INNOLUX 群創光電	AV 產品終止生產通知 The End of AV Product Life Letter	保管單位 Storage	市場
		保存年限 Retention Period	3年

Model name of phase out: EE050NA-04A

Issue date: 2013-1-16

HE050NA-01F

1.外觀差異 Appearance Difference Yes No

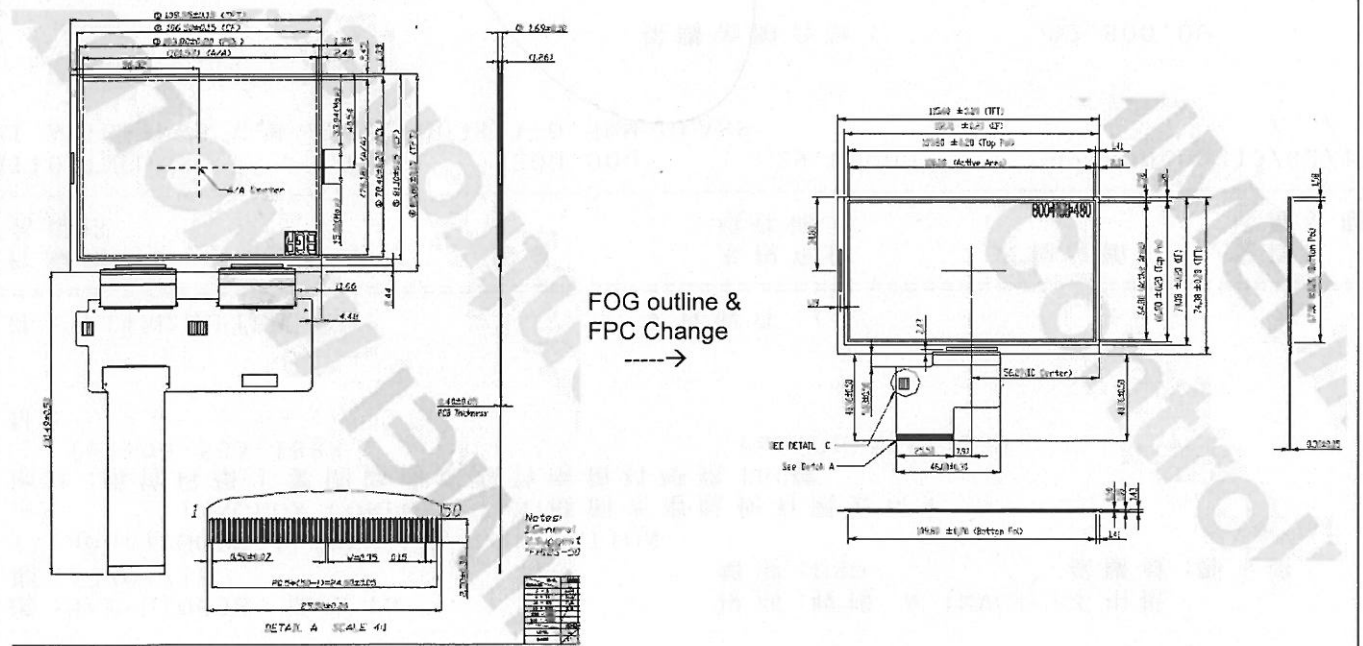
Item	EE050NA-04A	HE050NA-01F	Difference
Panel length(mm)	109.55	115.60	+6.05
Panel width(mm)	85.86	74.38	-11.48
Panel thickness(mm)	1.69	1.43	-0.26
FPC length(mm) From bezel edge	38	40	+2
Resolution	640*480	800*480	/
Transmittance	5.5	4.66	-0.84

1. 5DN是使用交流的VCOM；而5DH使用直流的VCOM！

2. 5DN在PCB上設置Dithering function；而5DH是通過客戶端來設置Dithering function！

客戶那邊要把5DN交流VCOM，改成5DH使用的直流VCOM！

而 5DN 的 47 48 PIN 客戶端在不改變的情況下，通過轉接線來與 5DH 屏兼容！
